Newport City Council – Planning Consultation

Application Number: 24/0827

Proposal: OUTLINE APPLICATION FOR A NEW DWELLING

Site: 1 Trinity View Caerleon Newport NP18 3SU

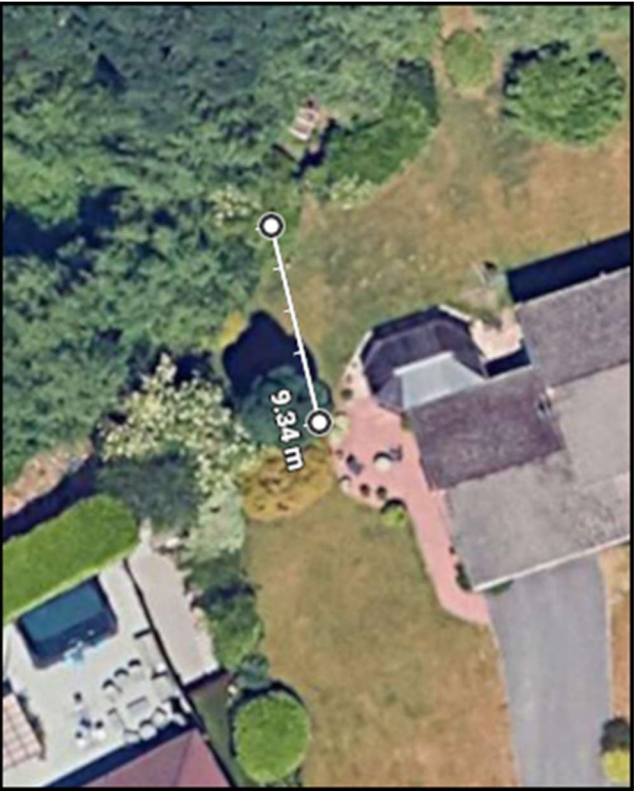
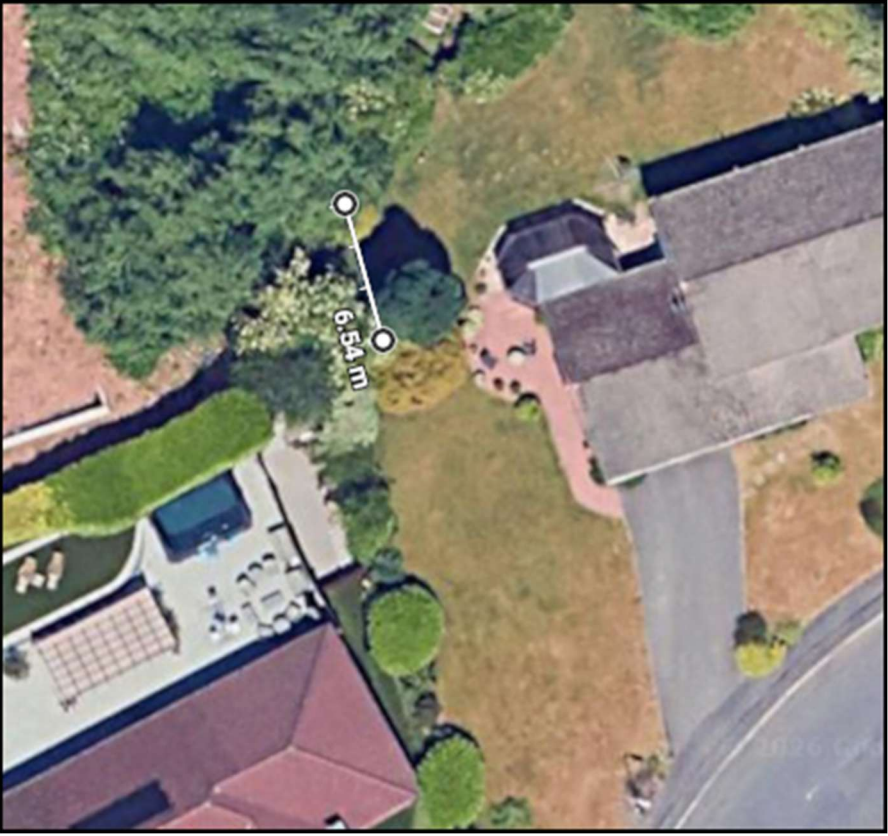
The provided site plan indicates a conifer close to the proposed dwelling, albeit proposed for removal. Using aerial mapping, the canopy of a small group of woody vegetation to the north is approximately 5m from the proposed dwelling and the woodland edge some 10m, and therefore all within potential influencing distance of the proposed dwelling and construction working space etc (refer to Google Imagery screenshots below).

Therefore, a tree survey and tree constraints plan will be required at this Outline Planning Stage. The full application will need to include a combined Arboricultural Implications Assessment and Arboricultural Method Statement. If the full application is >12 months later than the tree survey date, then this will need to be updated at the application stage.
